14/04139/FULL1 | Demolition of existing dwelling and erection of a part two/part three storey building comprising 9 two bedroom apartments and 14 car parking spaces | Sunset Hill Hillbrow Road Bromley BR1 4JL

Ravensbourne Valley Preservation Society is a residents' association of approximately 500 subscribing members which concerns itself with the quality of the built environment in and around Shortlands.

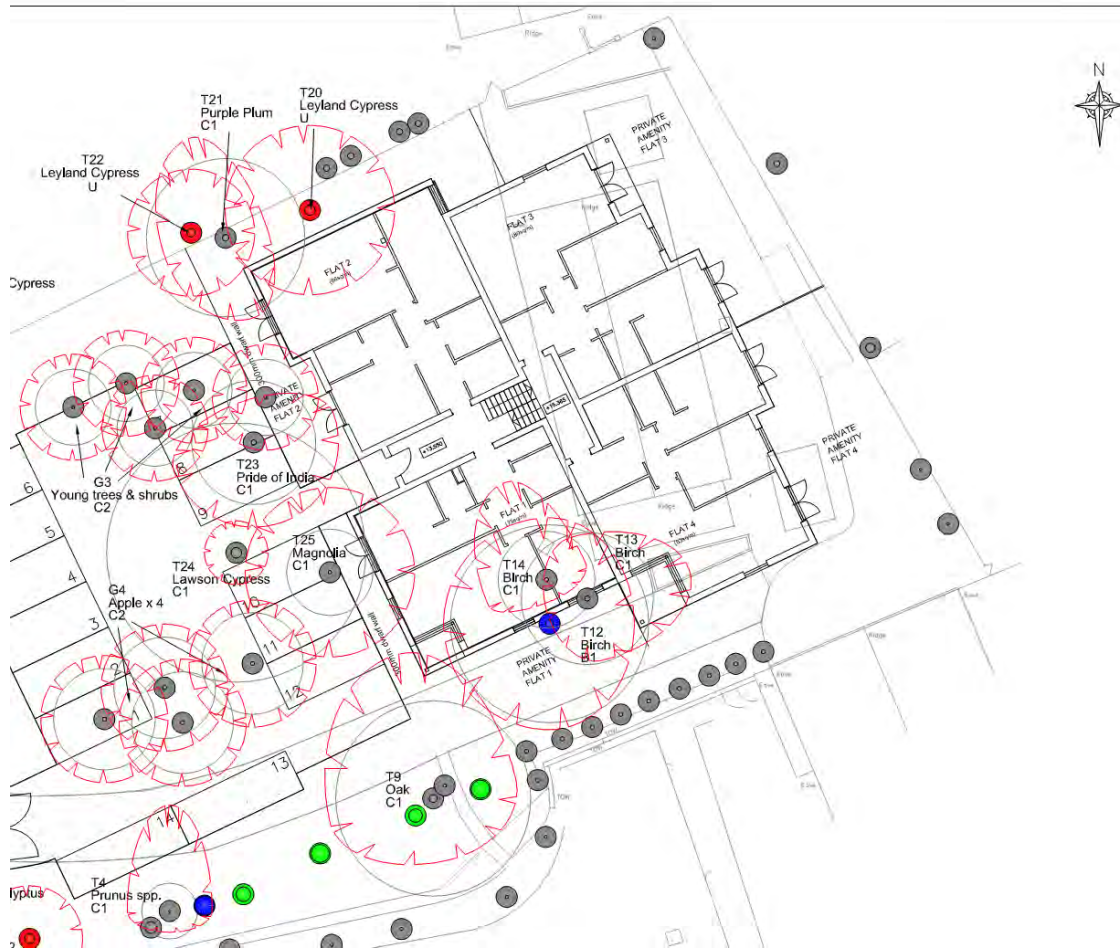
The footprint of the proposed building would be very much more substantial than the existing footprint and in addition would be far further forward than the existing building line. See the following diagram: -

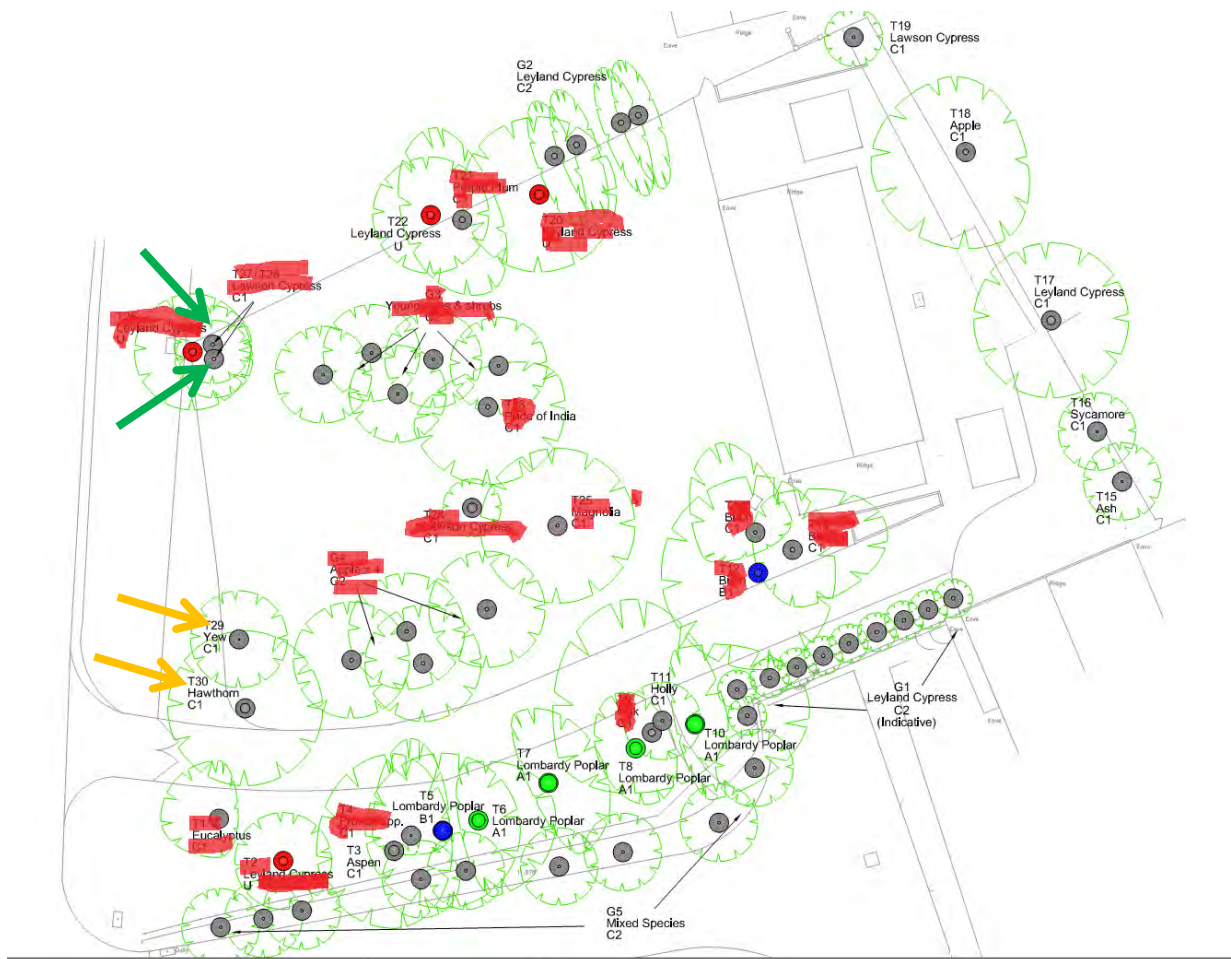
We are particularly concerned about landscaping. The above diagram shows trees that are to be removed by crossing them out in red. Just two trees, T29 and T30 will exist north of the driveway in the front garden should tree removal proceed as proposed. These we have indicated with an orange arrow. In addition, the whole of the front boundary is densely planted with other shrubs/trees which are not shown above and which would also be removed. Please see below.

Consideration should be given to retaining trees T27 and T28 on the north west corner of the plot (far left, above picture). This would enable there to be mature screening at the front of the property. We have indicated these with green arrows on an earlier diagram.
